On Complexity and Reliability

Contribution to 802.3dm Task Force

July 28, 2025

Ragnar Jonsson - Marvell

New-TDD Control State Diagram

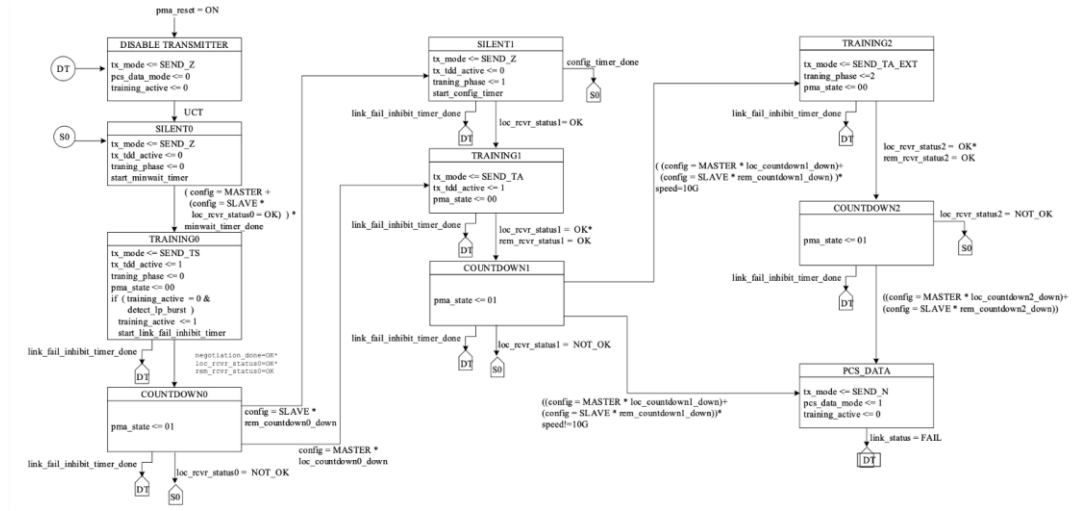
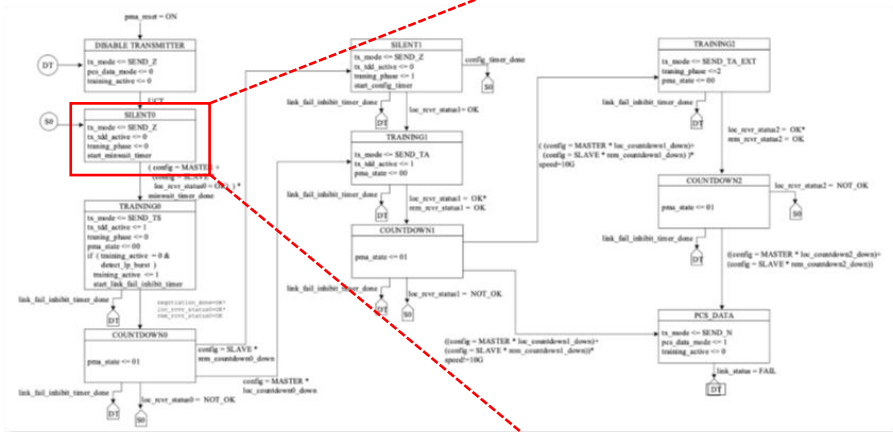
- The control state diagram for the New-TDD was introduced in [Baseline_Text_TDD_051125.pdf](https://www.ieee802.org/3/dm/public/051125/Baseline_Text_TDD_051125.pdf)
- The state diagram has 10 different states, and inside some of these states there are sub-states related to the TDD operation
- The following slides show an attempt to describe at a high level the control flow for PHYs based on the New-TDD

SILENT0 State

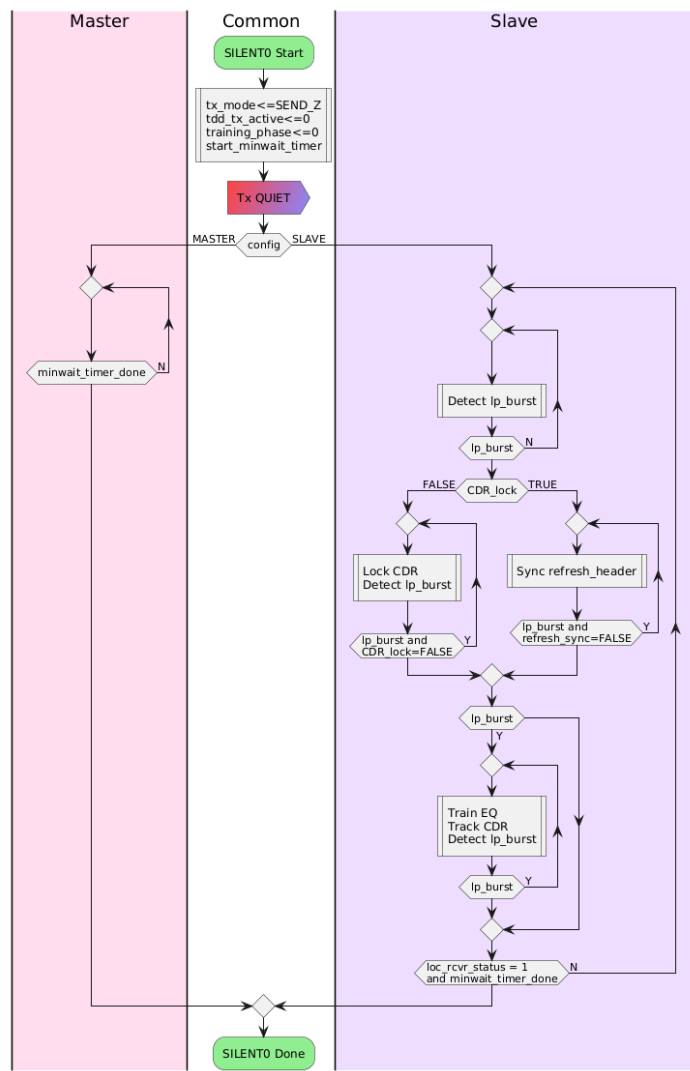
$$E - N = 9$$

TRAINING0 State

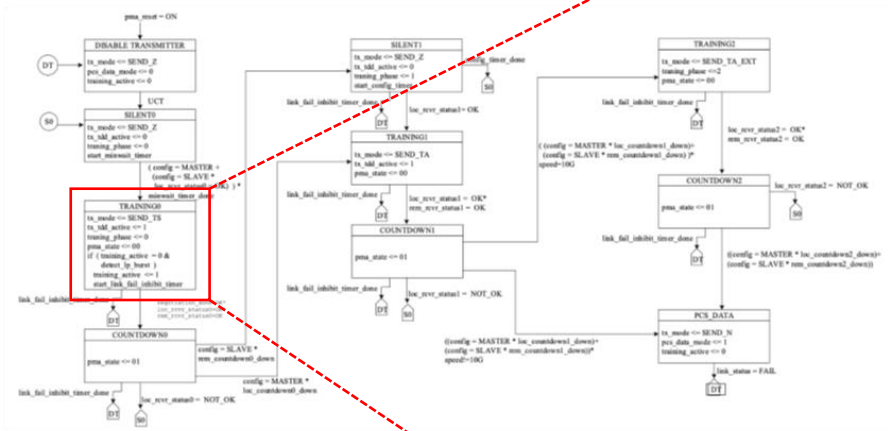
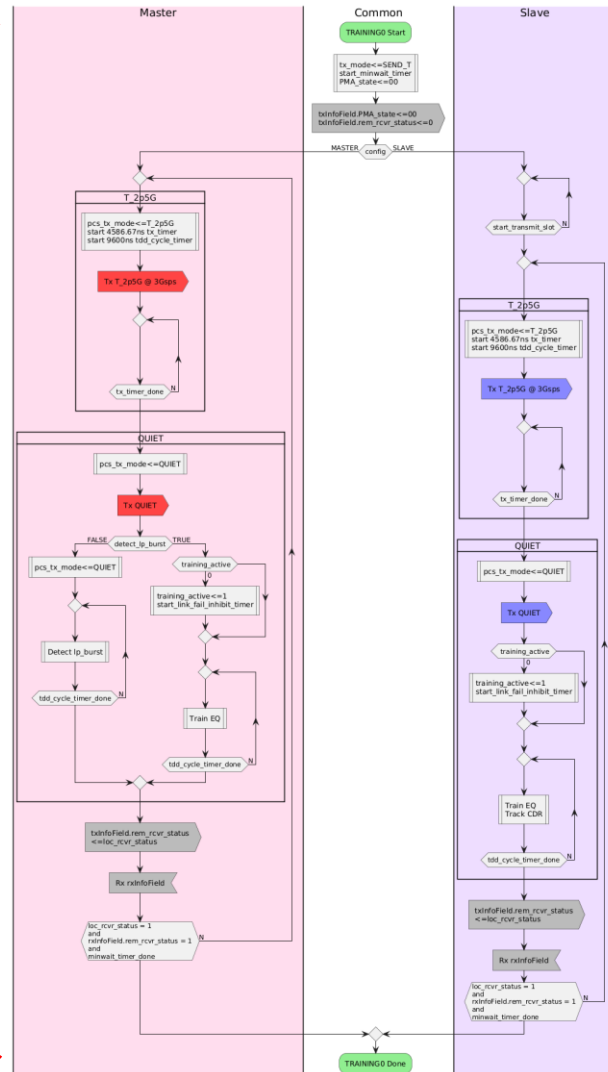
E-N = 12

COUNTDOWN0 State

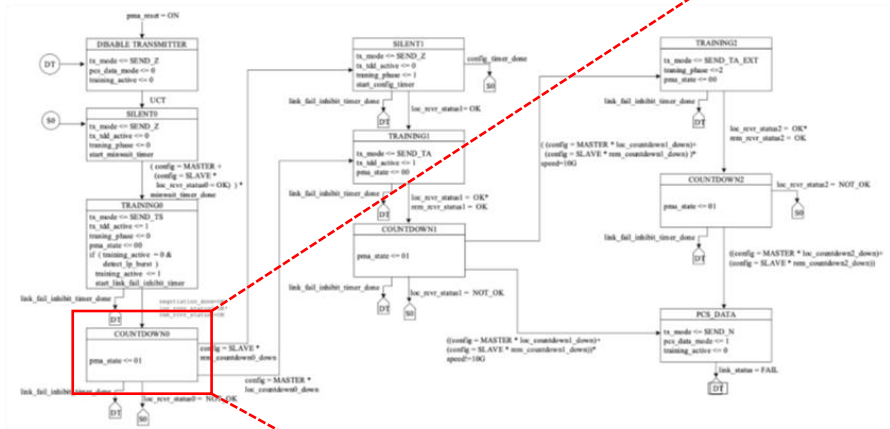
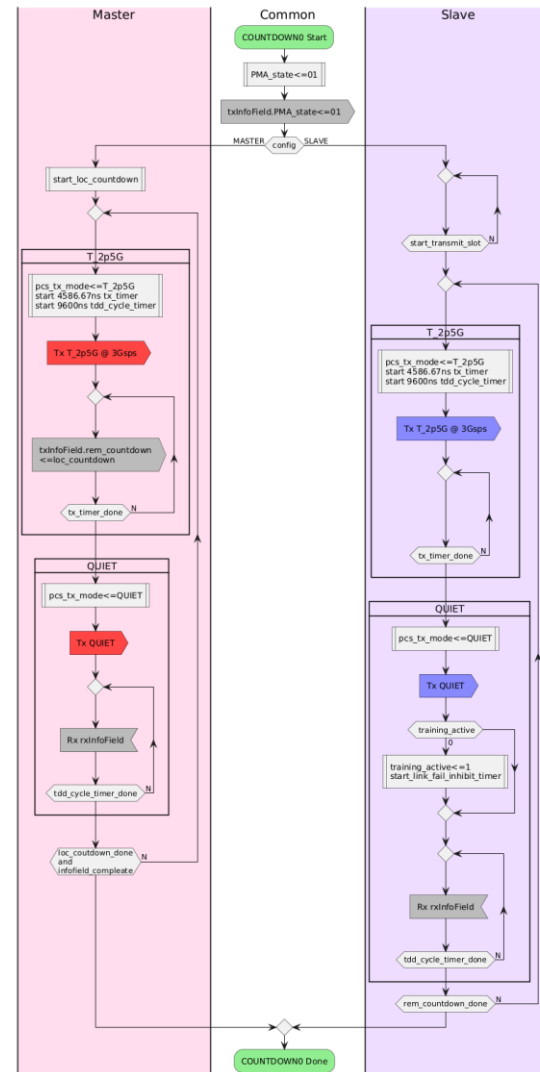
$$E-N = 9$$

SILENT1 State

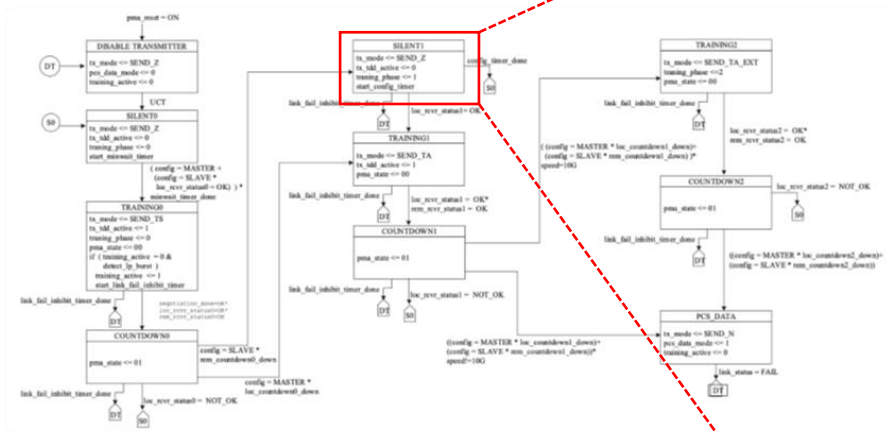
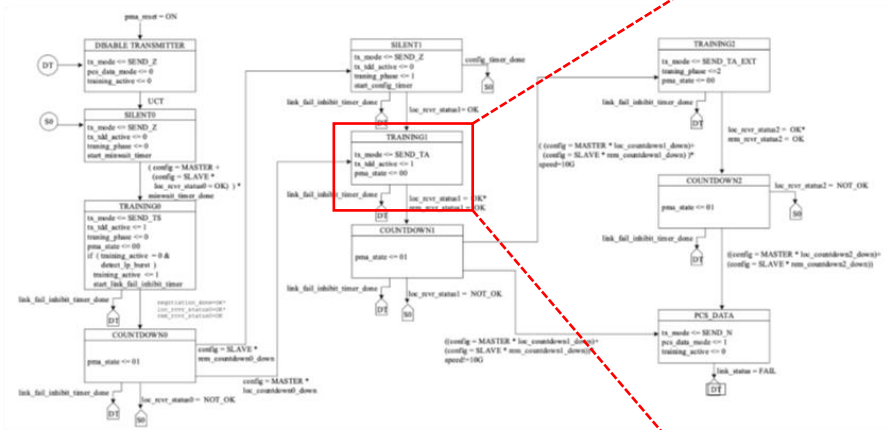
E-N = 5

TRAINING1 State

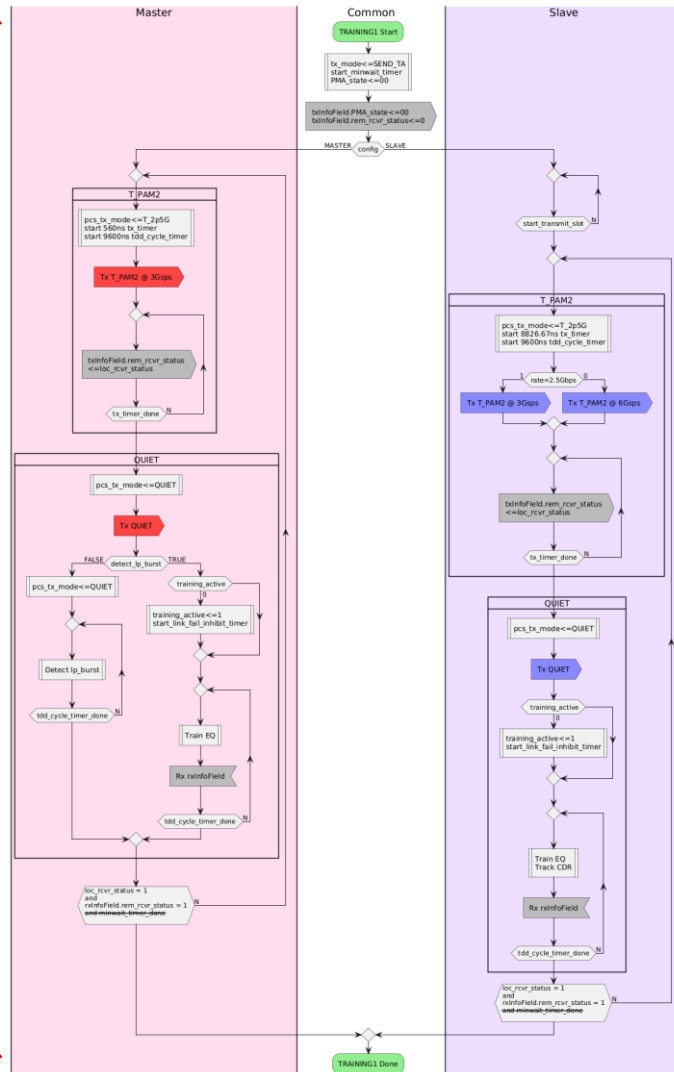
E-N = 13

COUNTDOWN1 State

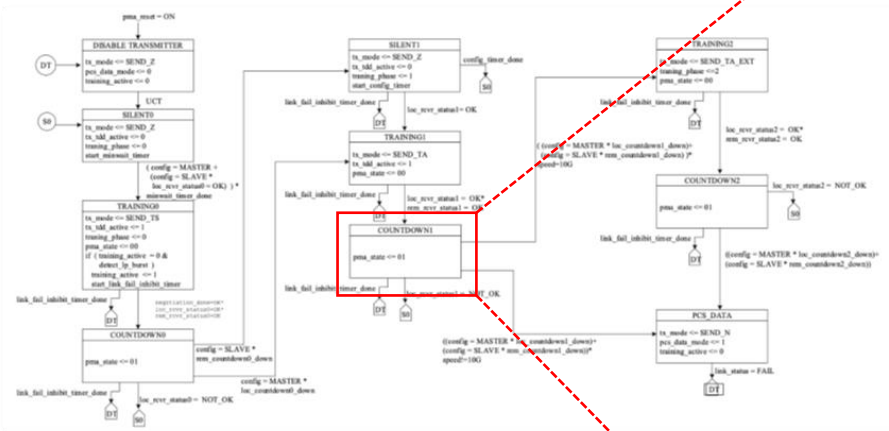
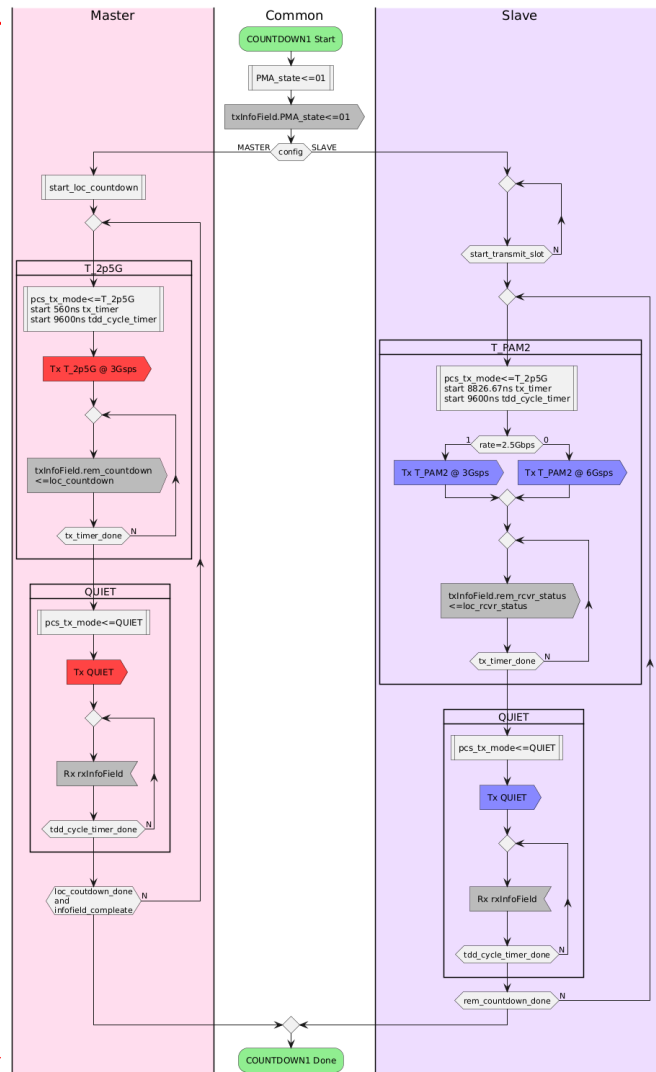
$$E-N = 9$$

TRAINING2 State

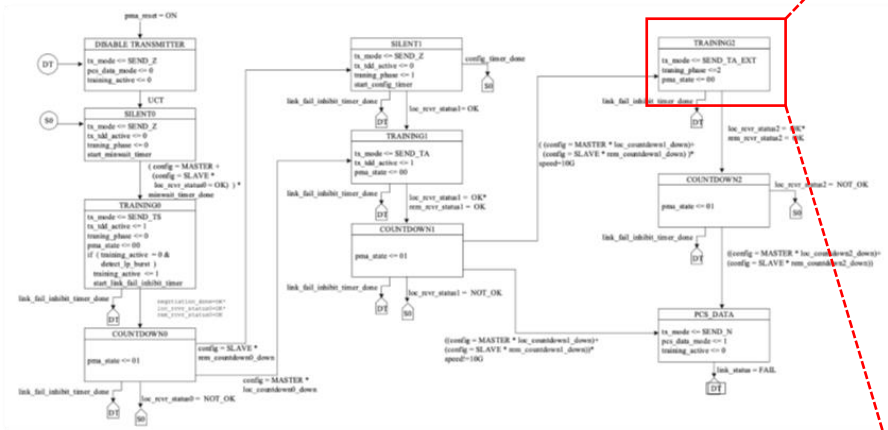
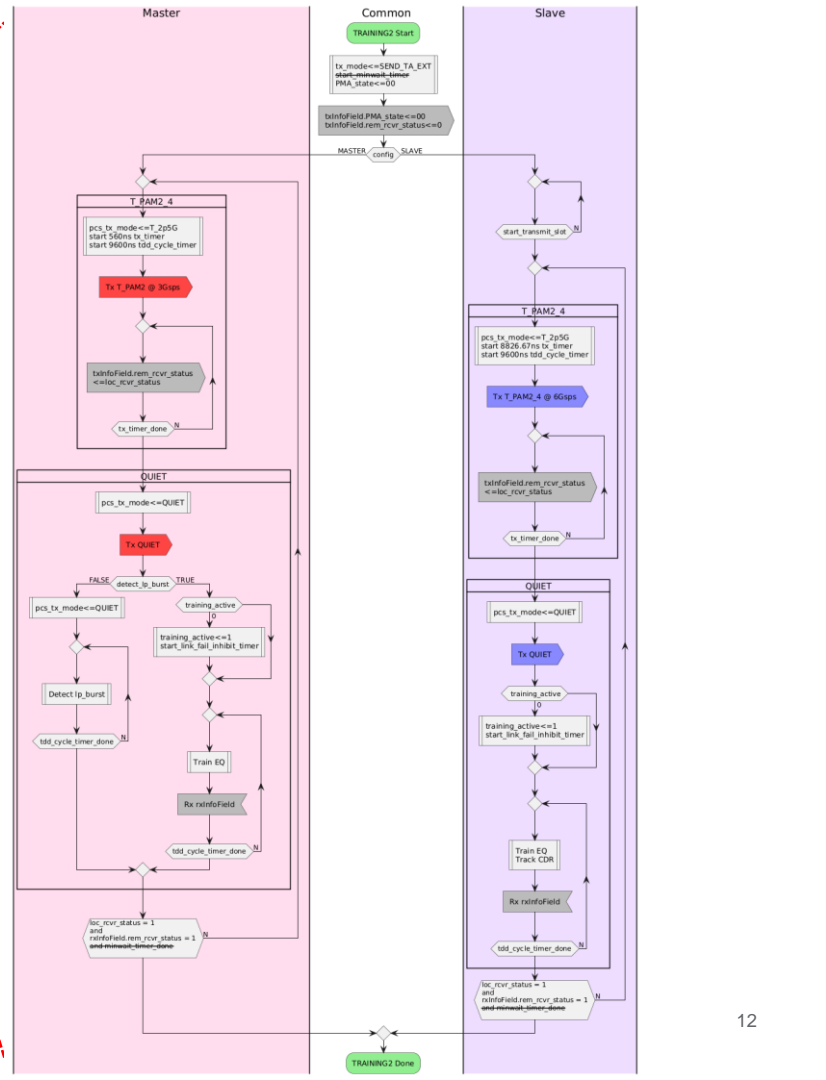
E-N = 12

COUNTDOWN2 State

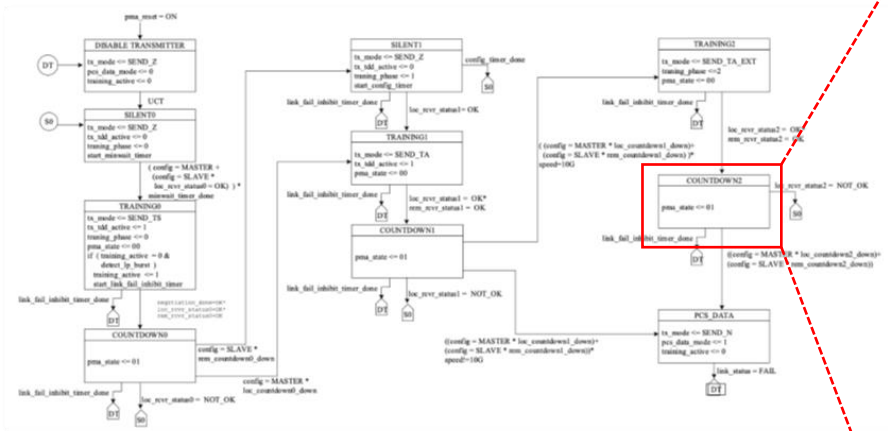
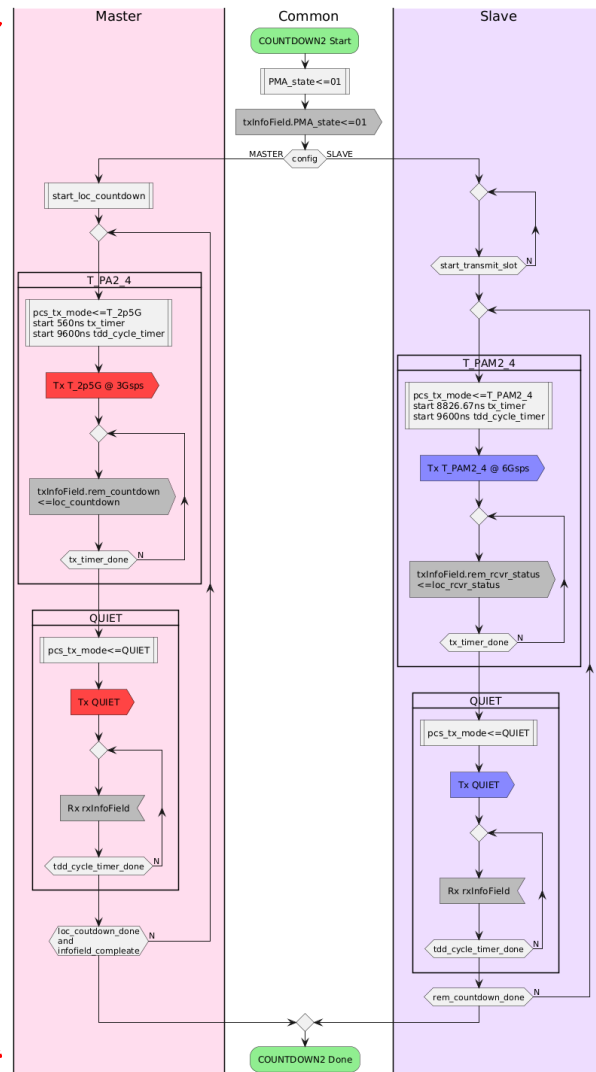
$$E-N = 8$$

New-TDD Combined

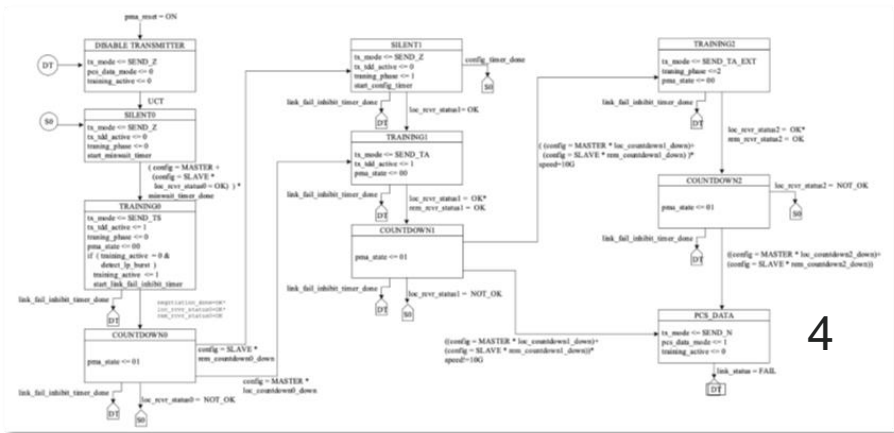
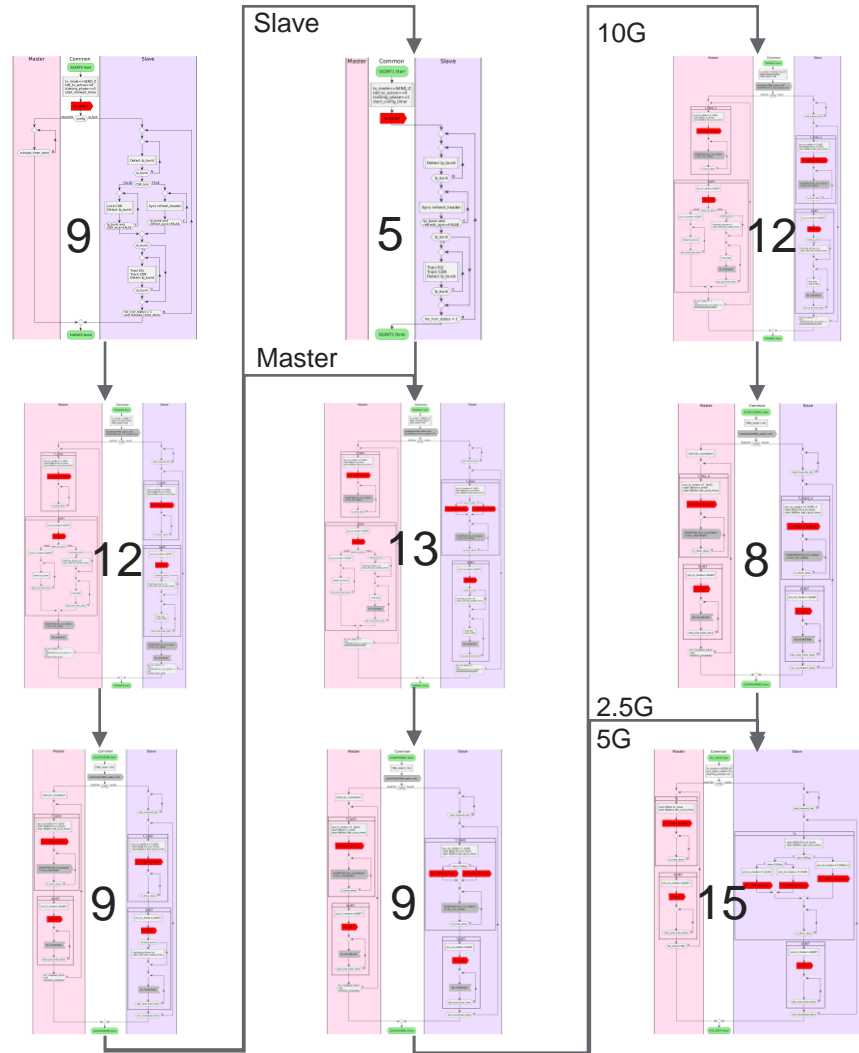
$$E-N = 9+12+9+5+13+9+12+8+15+4 = 96$$

Cyclomatic Complexity of SILENT0

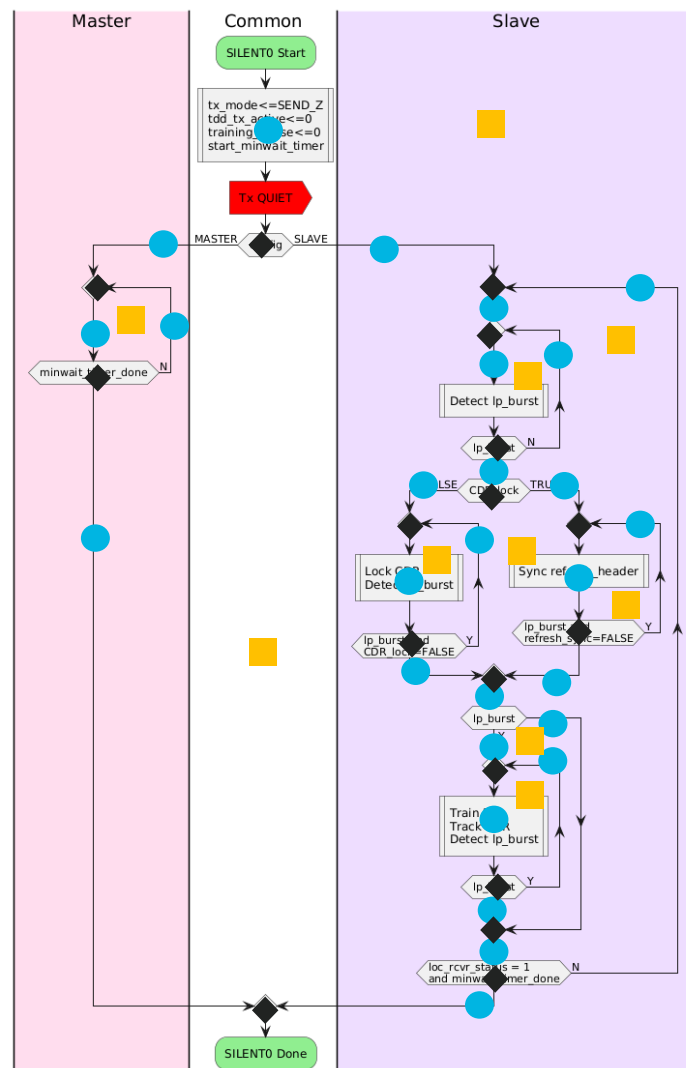
$$E - N = 9$$

$$M1 = E - N + 2P = 26 - 17 + 2 = 11$$

$$M2 = E - N + P = 26 - 17 + 1 = 10$$

$$M3 = \text{num. loops} = 10$$

$$M4 = \text{num. paths} = (2 + 2 * 2 * (2 + 2) * (2 + 1)) = 50$$
